CERTIFICATE OF APPROPRIATENESS

Applicant: Scott Fitzharris, owner; Sam Gianukos, agent

Property: 1208 Cortlandt Street, Lot 15, Block 189, Houston Heights East Subdivision. The property includes a two-story wood frame, 2,902 SF, single-family house on a 6,600 SF lot

Proposal: Alteration – the applicant proposes to:

COA DRAWINGS PRESENTED TO HAHC:
PULLED FROM ORIGINAL "APPROVED" COA REPORT

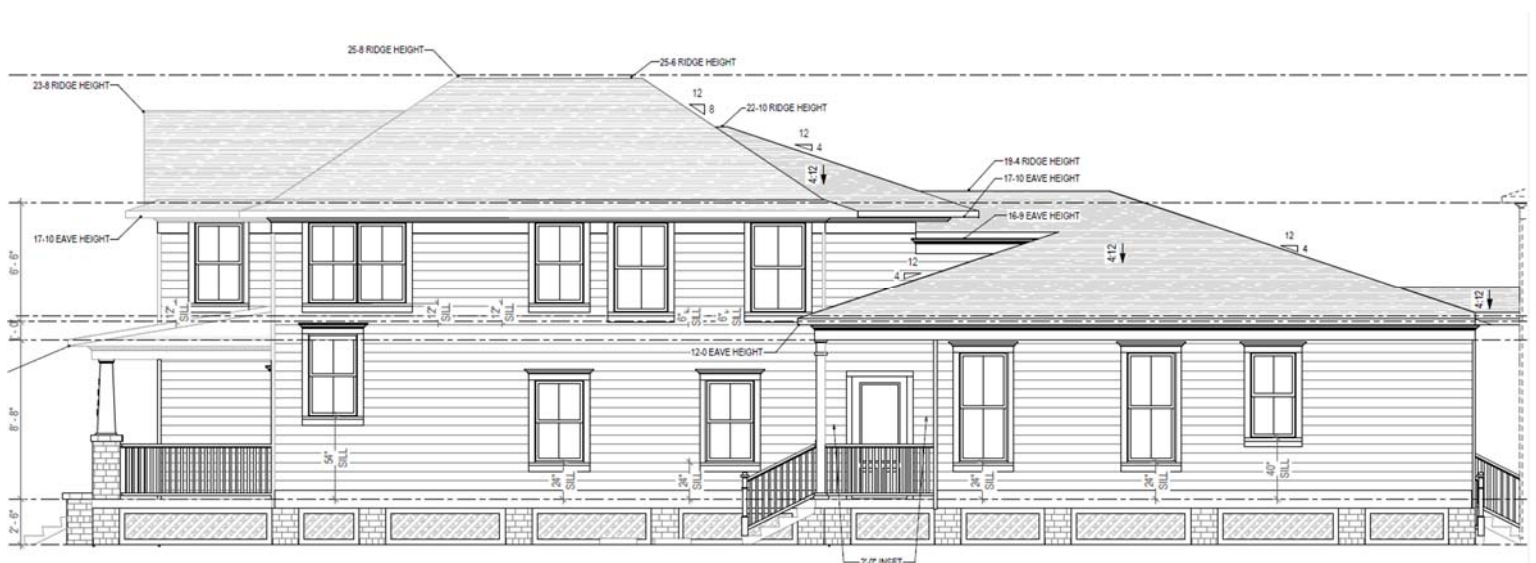
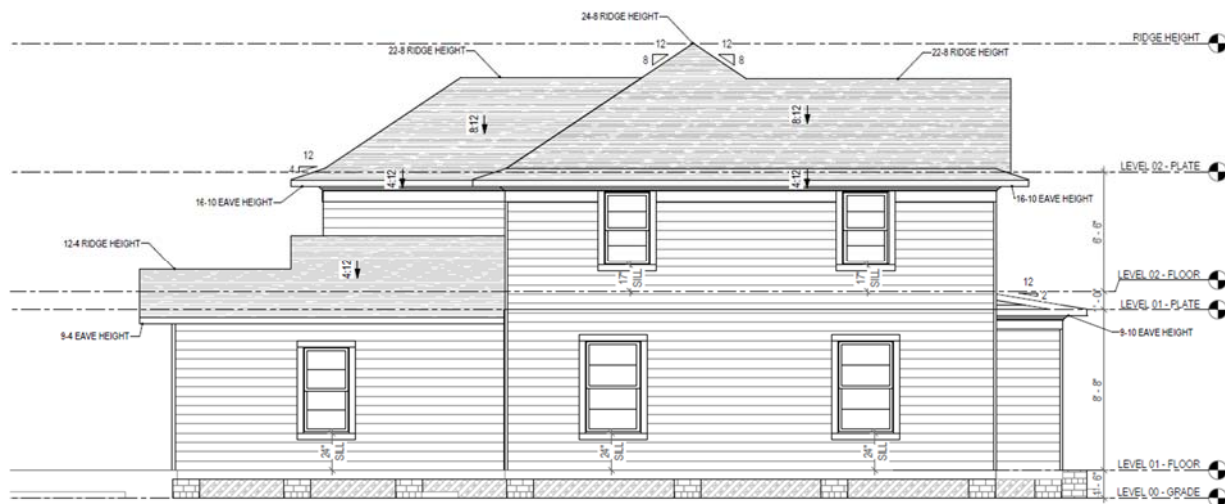
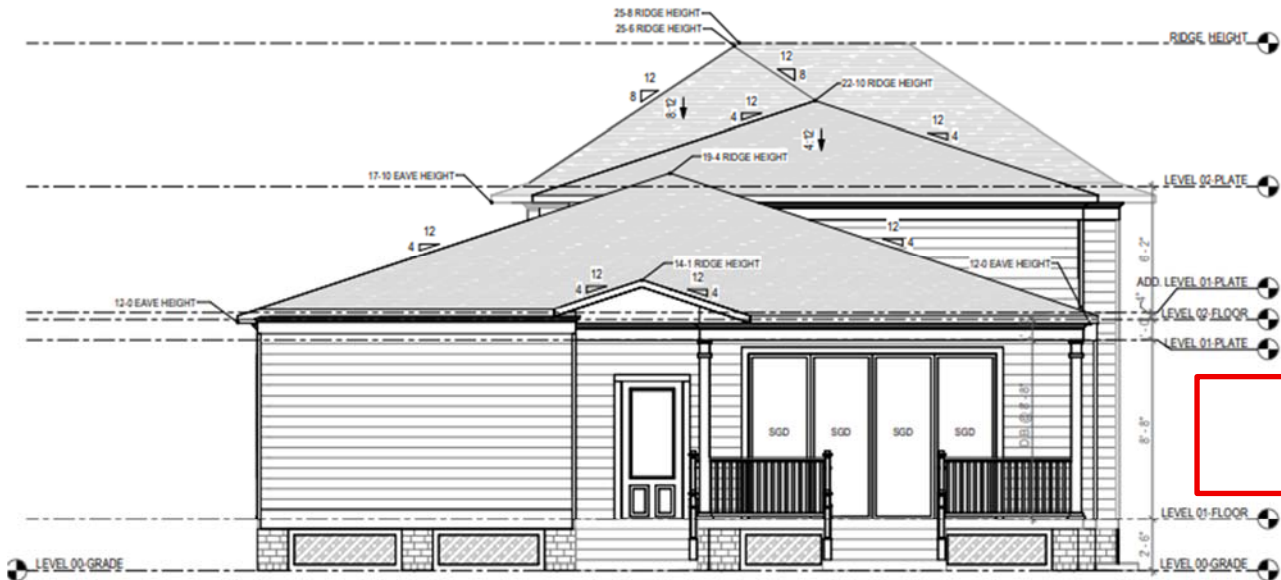
- Remove the existing siding and install smooth cementitious siding.
- Approved COA (HP2025-0021) scope of work exceeded during construction.

Recommendation: Denial of COA issuance of COR for work performed outside of scope.
Install wood siding in place of cementitious siding on contributing structure.

COA REVISION DRAWINGS UPLOADED BY AGENT 10/06/2025:
PULLED FROM PRESERVATION TRACKER 10/30/2025 @ 5:31 PM
NOTES NOT PROVIDED WITH THE ORIGINAL APPROVED COA UPLOADED 2/12/2025

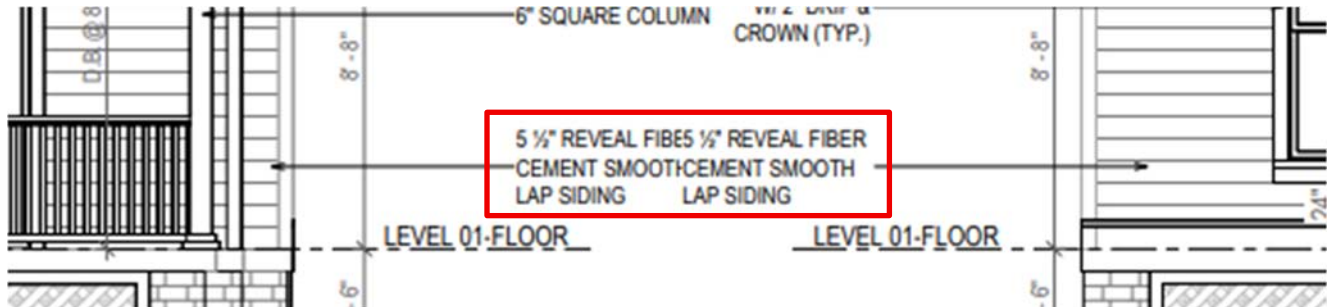
NOTE:
REMOVE ALL ORIGINAL SIDING
AND RE-USE AS NEEDED

NOTE: SIDING

REMOVE ORIGINAL SIDING AND REUSE AS
APPLICABLE
